AFMSS
U.S. Department of the Interior
BUREAU OF LAND MANAGEMENT

Well Name: AMAX 24 FEDERAL
Well Location: T23S / R31E / SEC 24 / SWNW / 32.2917251 / -103.7389485
County or Parish/State: EDDY / NM
Well Number: 7
Type of Well: OIL WELL
Allottee or Tribe Name:
Lease Number: NMNM40655
Unit or CA Name:
Unit or CA Number:
US Well Number: 3001527129005S1
Operator: OXY USA INCORPORATED

Notice of Intent

Sundry ID: 2907784
Type of Submission: Notice of Intent
Type of Action: Plug and Abandonment
Date Sundry Submitted: 04/23/2026
Time Sundry Submitted: 08:10
Date proposed operation will begin: 07/01/2026

Proposed Wellbore
AMAX 24 FEDERAL 007

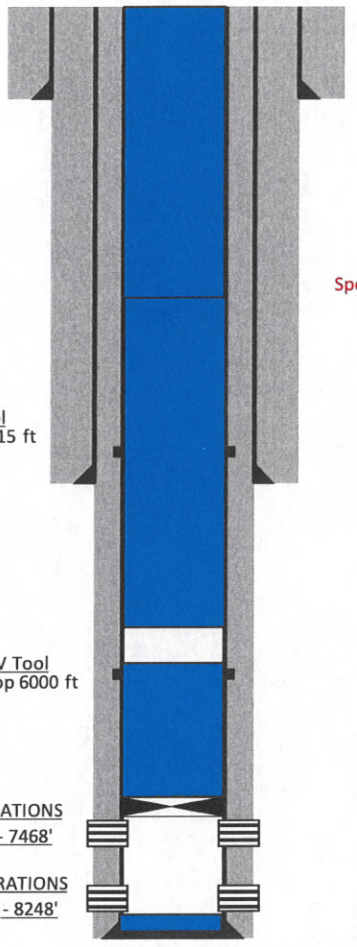
SPOT 142 SX CMT FROM 1400' TO SURFACE
VERIFY CMT TO SURFACE

Spot 203 sxs CMT from 3400' to 1400'. WOC and Tag.

SPOT 203 SX CMT FROM 5400' TO 3400' WOC AND TAG

RUN CBL FROM 5850' TO SURFACE

SET CIBP @ 6982'. LEAK TEST 500 PSI 30 MIN
SPOT 105 SX CMT Class C FROM 6982' TO 5950' WOC AND TAG

SPOT 30 SX CMT FROM 8383' TO 8145'. WOC and Tag.
